ROLLING MEADOWS SUBSTATION FINAL DRAINAGE REPORT

PCD FILE #

PPR2619

June 22, 2026

DETENTION BASIN OUTLET STRUCTURE DESIGN

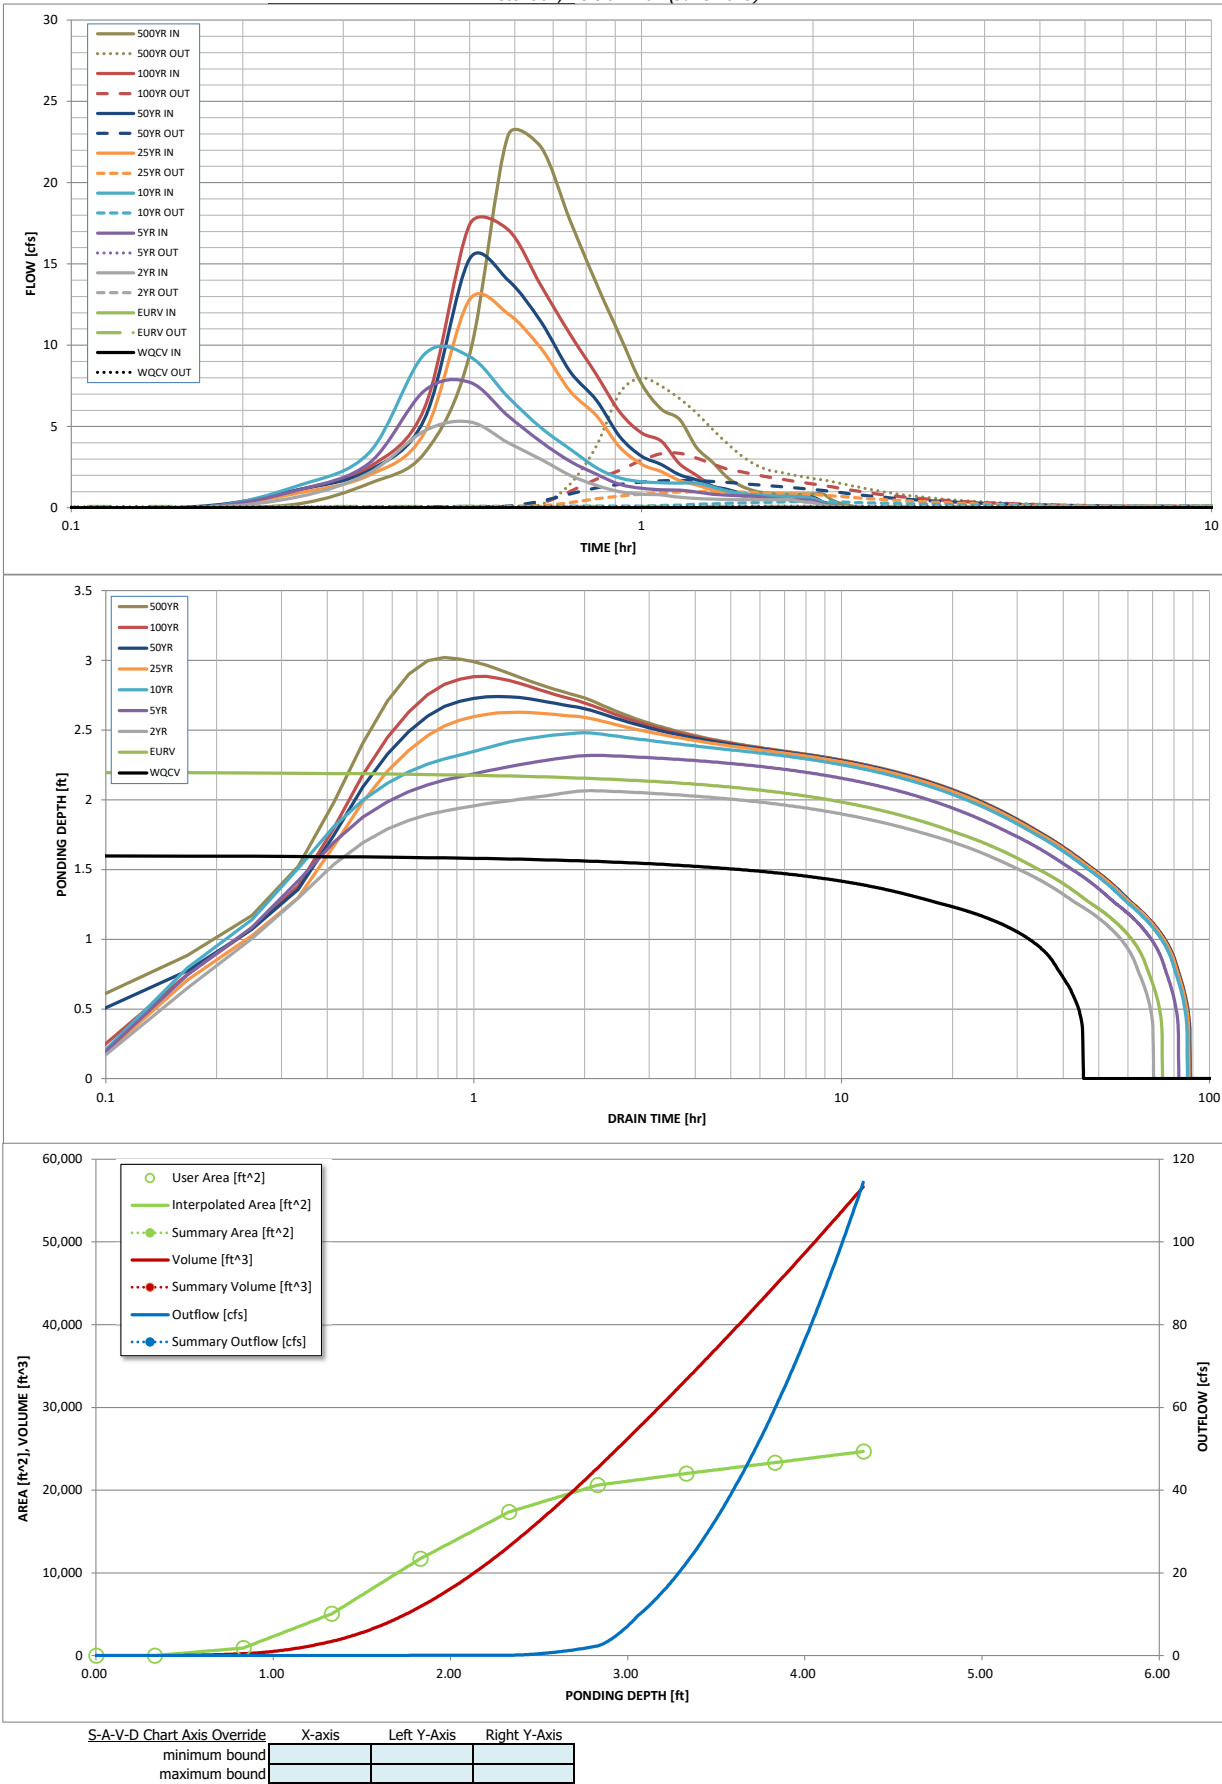
The emergency spillway shouldn't be activated in the 100-yr storm event, the pond outlet structure should be designed for the 100-yr.

Site Maps & Design Drawings

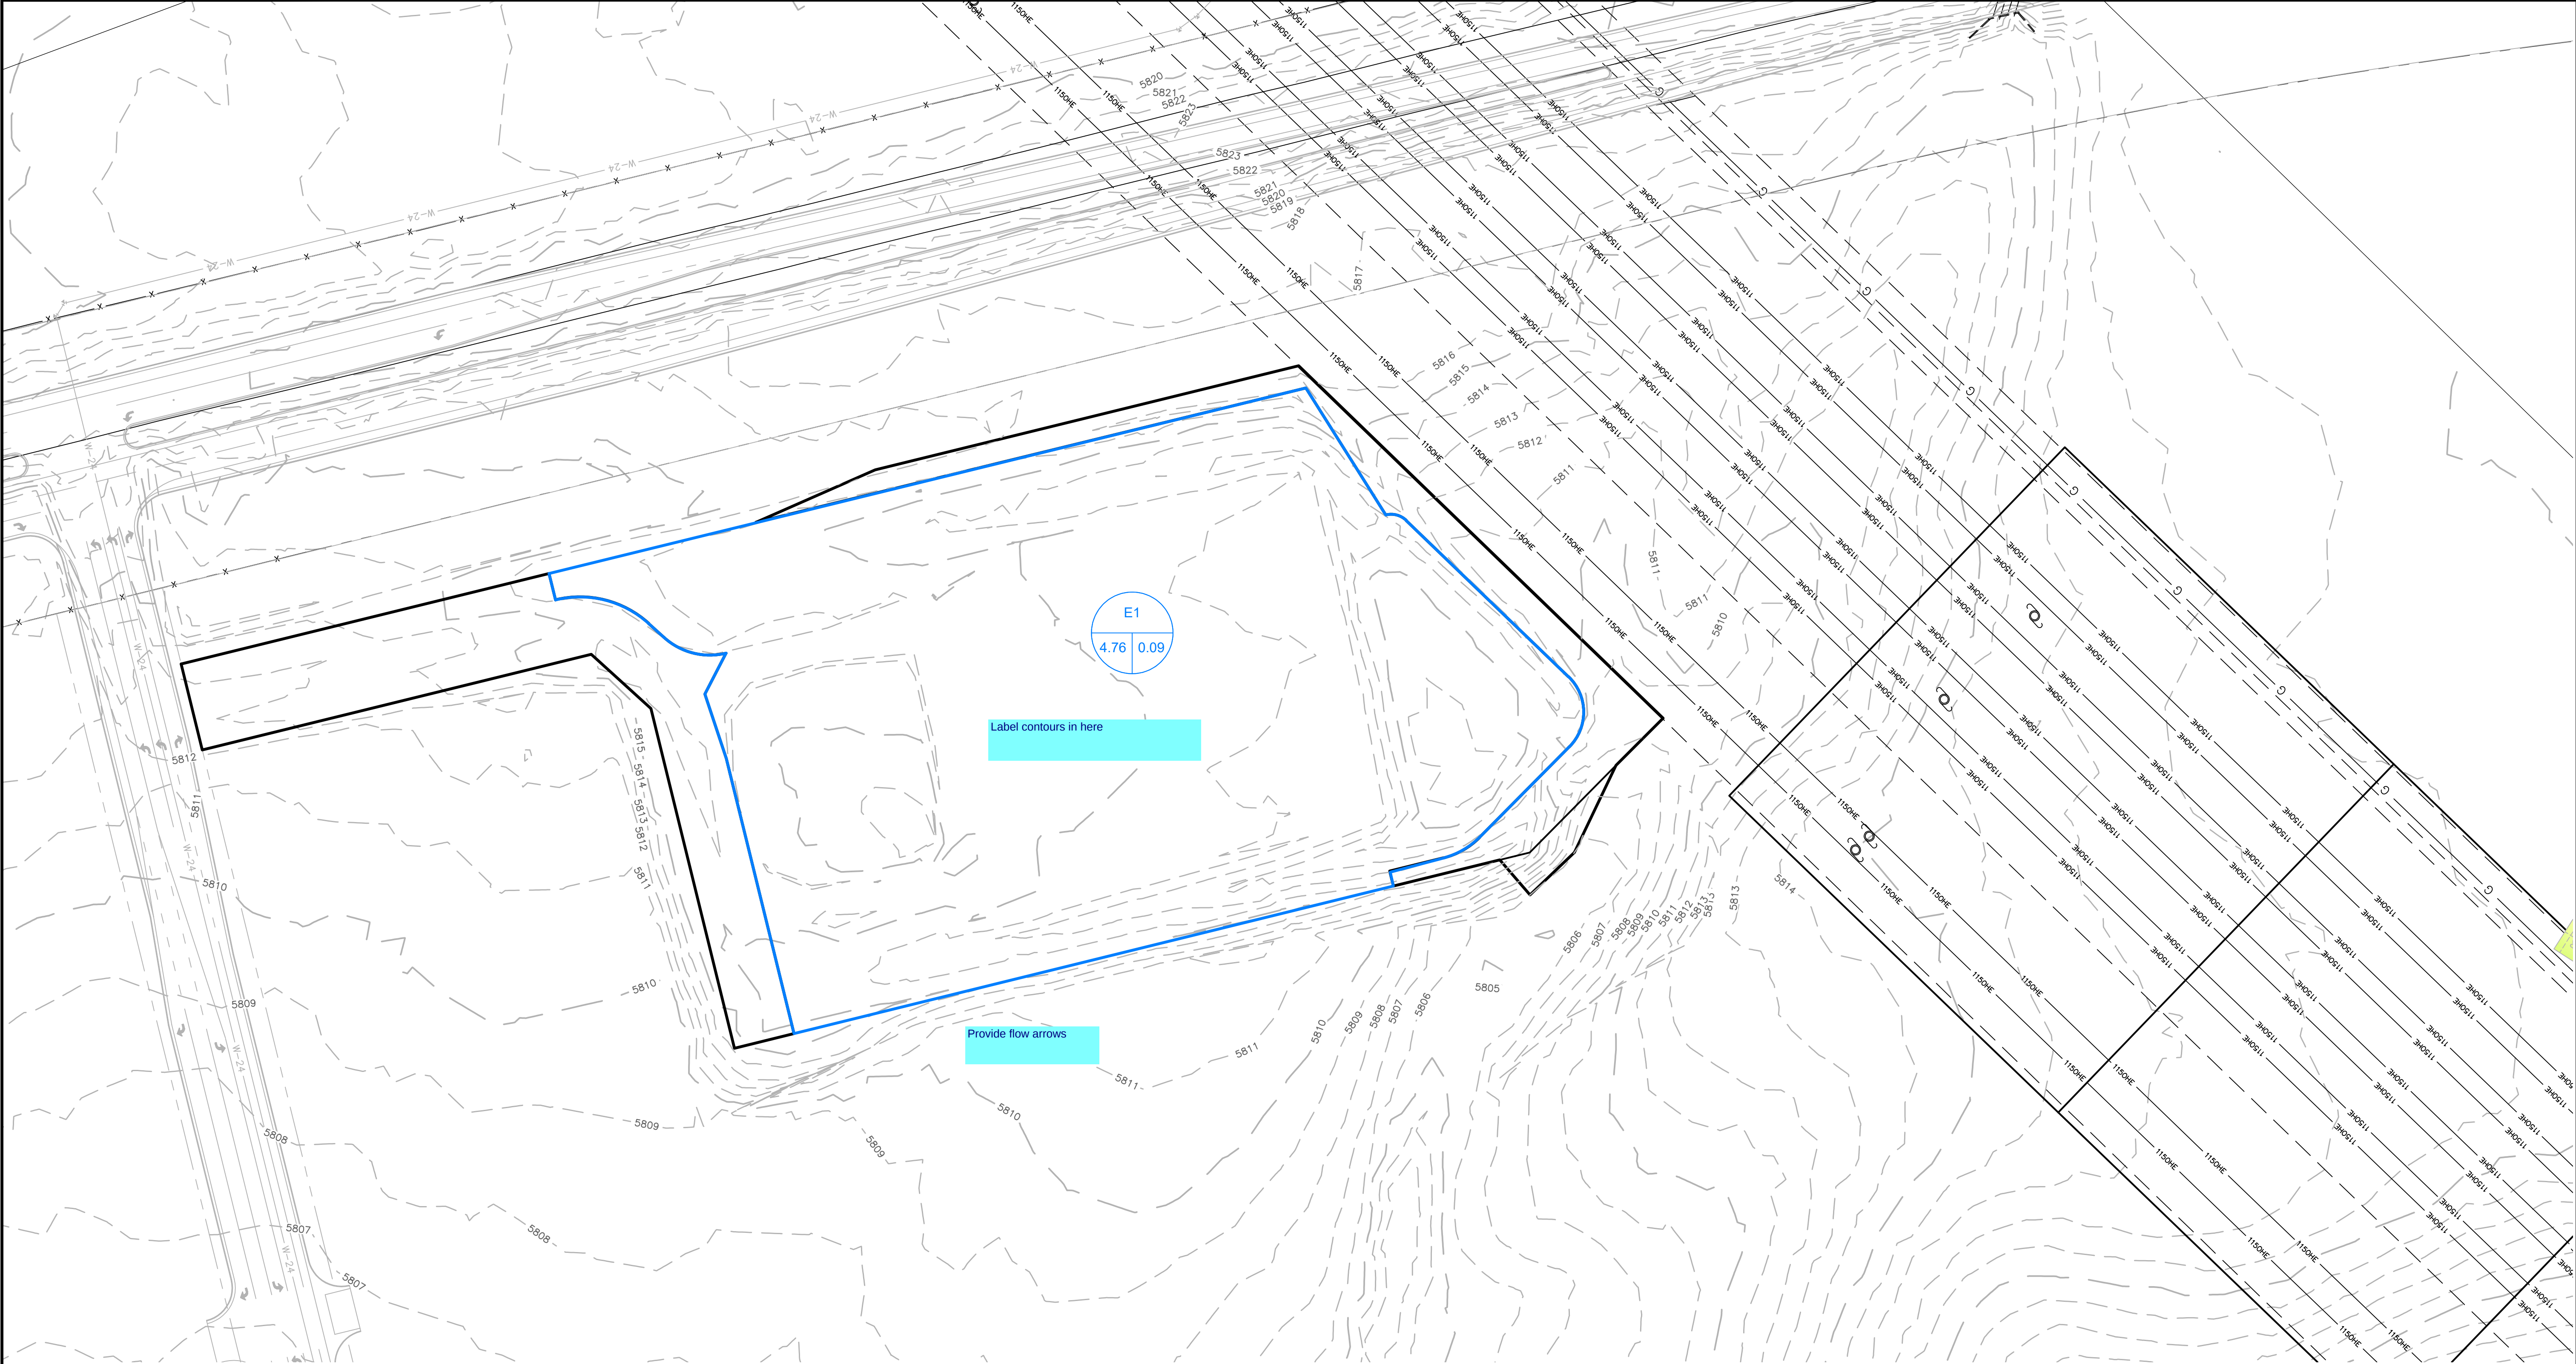
Why? Entire project site should be analyzed, even if it's not treated. Please provide additional basins for these areas and determine existing flows.

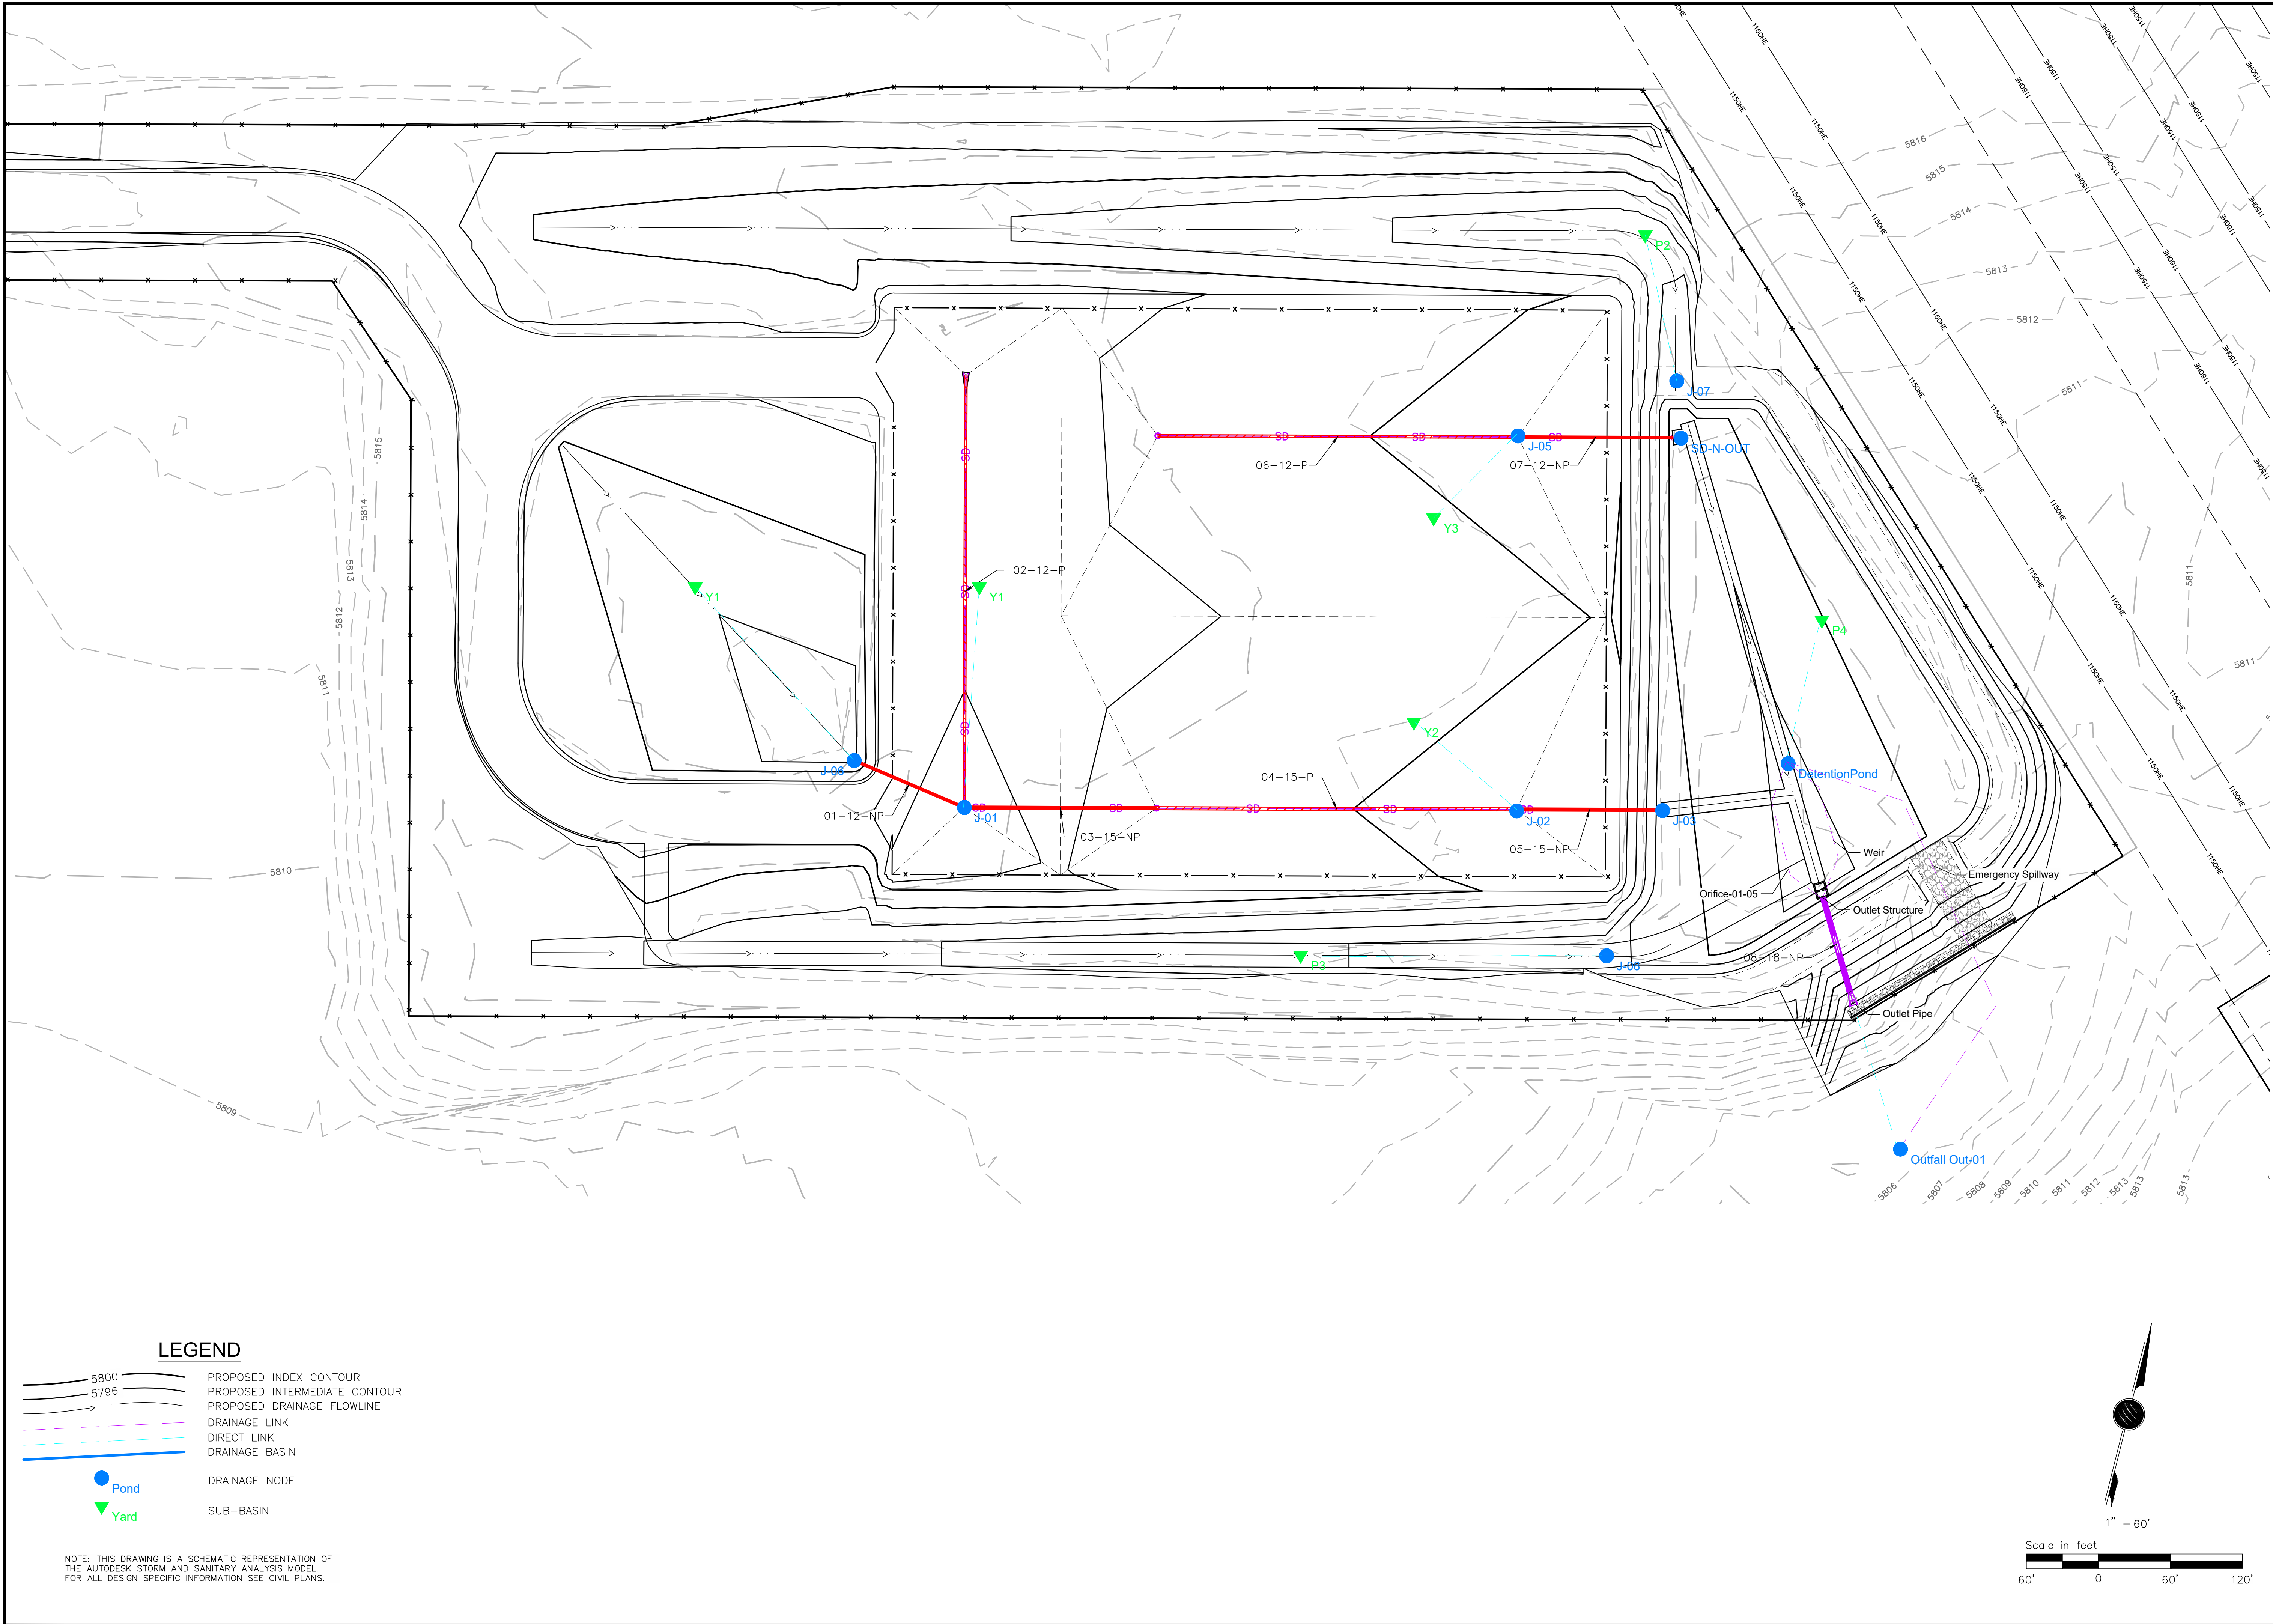
entire project site
e analyzed, even
treated. Please
additional basins
areas and
e existing flows.
